Subject: 10CFR21 Reporting of Defects and Non-Compliance -  
Engine Systems, Inc. Report No. 10CFR21-0117, Rev. 0

Motor Operated Potentiometer Without Pre-Position Feature  
PNs: 72-07900-100-ESI, 2-04E-184-103-ESI, 2-00G-009-002-ESI

**Report No. 10CFR21-0117**

**10CFR21 REPORTING OF DEFECTS  
AND NON-COMPLIANCE**

Photo 1: Desired Return-to-Center Cam Arrangement

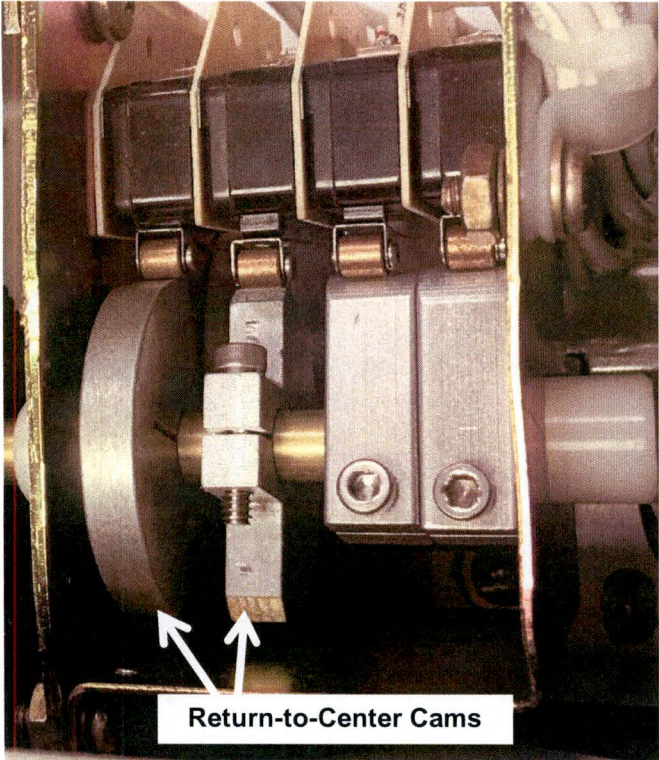
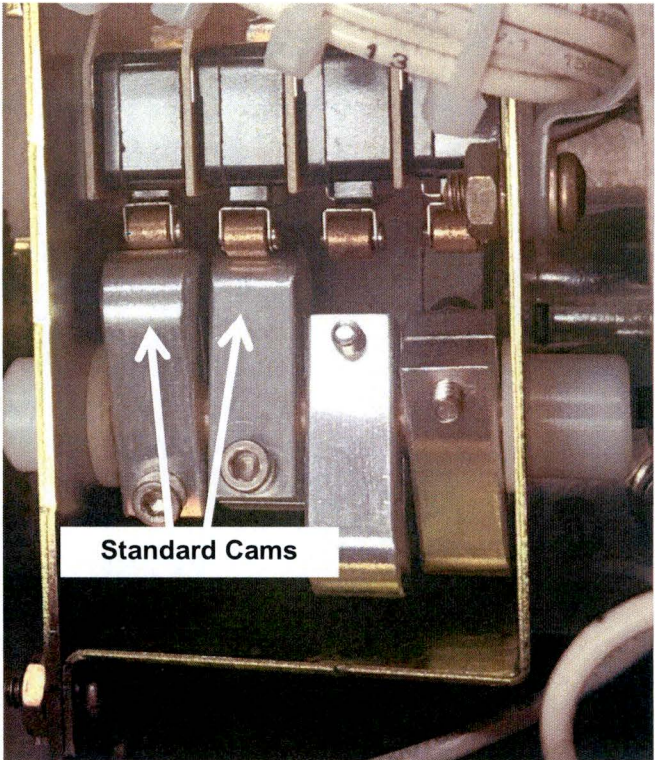
The Basler MOP selected by ESI for the assembly was model MOC2103. A review of Basler model MOC2103 indicates that it is not a return-to-center style device and instead contains a standard cam arrangement. Photos on the following page depict the differences between the two cam arrangement styles. ESI inadvertently selected the incorrect model for this application. Reviewing the qualification testing performed by ESI revealed that ESI's testing duplicated the original Portec test procedure (whereby one cam is set to close above setpoint and one cam is set to close below setpoint). However, the testing was shown to be inadequate to fully ensure the return-to-center functionality. Though the cams were properly set above and below setpoint, a further verification that the unit would return to center, even if sufficiently away from setpoint, was not performed. For installations that rely on the pre-position function, it is possible that the MOPs supplied by ESI would not return the potentiometer to setpoint. Since the MOP is used to set output voltage of the emergency diesel generator, the consequences of this issue are that the EDG may not maintain voltage within its required range to support its safety-related loads.

ESI selected the incorrect MOP to be used for this assembly. The original MOP used was an Portec/NEI P/N 72-07900-100 which became obsolete in the 1990s. ESI offered a replacement assembly (using the "-ESI" suffix) that included a Basler brand MOP, modified by replacing the factory supplied potentiometer to replicate the original Portec design. The original Portec MOP had the return-to-center feature and Basler offers some models with return-to-center and some without. ESI inadvertently selected the model without return-to-center.

- To prevent recurrence of this issue, ESI is implementing a revision to the procurement process for this assembly to update the part number of the MOP utilized. In addition, the dedication inspection and testing activities are being revised to ensure testing properly validates the return-to-center feature. This action is currently underway and will be completed prior to any future shipments.
